8th Edition (2023) Florida Building Code

Proposed Code Modifications SWIMMING POOL DETAIL

TAC: Swimming Pool

SW9857

SECTION-AA

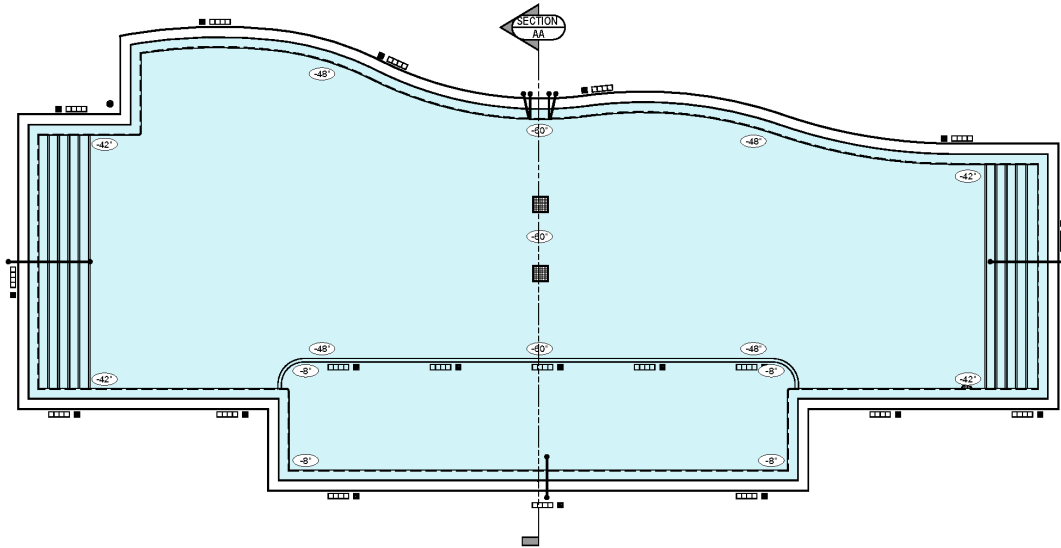
NOTE:
The pool shown here would not
be acceptable under current code.
The proposal would allow it.
